# Access Compliance Report

## Public Rights-of-Way

Intersection ID: 27660	Main Street: CATHERINE'S_MINE_CR	Cross Street: NOLEN_LN	Location: NE
ADA ID: 5B475545E0FD	Ramp Type: Perp	Initial Pass/Fail: Fail	Overall Compliance: No
Severity Score: 13.75			
Codes/Mitigation Info/Possible Solution		Field Measurements/Component Compliance

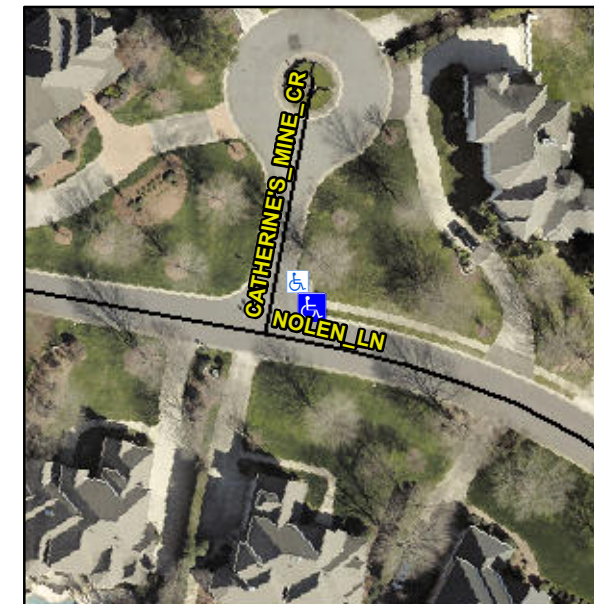
**Remove & Replace Entire Ramp.**

**Not Found, R304.2.2, R304.5.3**

Compliance	Description	Data	Compliance	Description	Data
N/A	Ramp Length (in)	87.0	No	Ramp Slope (%)	9.4
Yes	Ramp Width (in)	180.0	No	Ramp XSlope (%)	4.8
N/A	Flare Type LT	N/A	N/A	Flare Type RT	N/A
N/A	Flare Slope LT (%)	N/A	N/A	Flare Slope RT (%)	N/A
N/A	Flare Traversable LT?	N/A	N/A	Flare Traversable RT?	N/A
N/A	Landing Length (in)	N/A	N/A	DWS Provided?	N/A
N/A	Landing Width (in)	N/A	N/A	DWS Contrast?	N/A
N/A	Landing Slope (%)	N/A	N/A	DWS Length (in)	N/A
N/A	Landing X Slope (%)	N/A	N/A	DWS Full Width?	N/A
N/A	Landing Curb? (Y/N)	N/A	N/A	DWS Offset (in)	N/A
N/A	Shared Landing?	N/A			
N/A	Gutter Ponding?	N/A	N/A	Gutter Slope (%)	N/A
N/A	Gutter Lip Ht (in)	N/A	N/A	Gutter X Slope (%)	N/A
N/A	Painted X Walk1?	No	N/A	Painted X Walk2?	N/A
	X Walk 1 Direction	To SW		X Walk 2 Direction	N/A
N/A	X Walk 1 Width (in)	N/A	N/A	X Walk 2 Width (in)	N/A
	X Walk 1 Slope (%)	3.5		X Walk 2 Slope (%)	N/A
	X Walk 1 X Slope (%)	2.7		X Walk 2 X Slope (%)	N/A
